Re: Tipple Structure Amendment, D-10D Modification, Bear Canyon Mine, ACT/015/025, Emery County, Utah

Enclosed are 8 finalized copies of the text and plates for the Tipple Structure Amendment (95G), which was approved per Division letter dated 9/12/95, and the Ditch D-10D Route Modification (95J), which was approved per Division letter dated 9/18/95. Finalized copies have been combined since several of the Plates were involved in both amendments.

Figure 7.2-10 Ditch D-10D Cross-Section

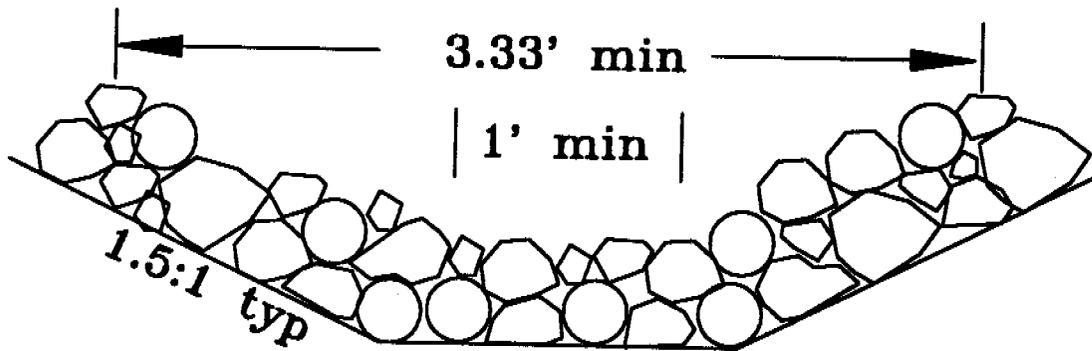
Prior to September, 1995, the flexible culvert was used to convey the drainage the entire length of the slope. A storm event which exceeded the design peak flow of the culvert destroyed a section of the flexible culvert from the uppermost belt tower below the coal storage bin to the coal processing pad. To reduce maintenance, this section will be replaced by a drainage channel as shown in Figure 7.2-10 and on Plate 7-1C.

The drainage channel is protected by 4 in. M.D. riprap. When the drainage reaches the Coal Processing pad, it will be conveyed into the lower flexible culvert C-2D (Plate 7-1C). Ditch designs are shown in Appendix 7-G.
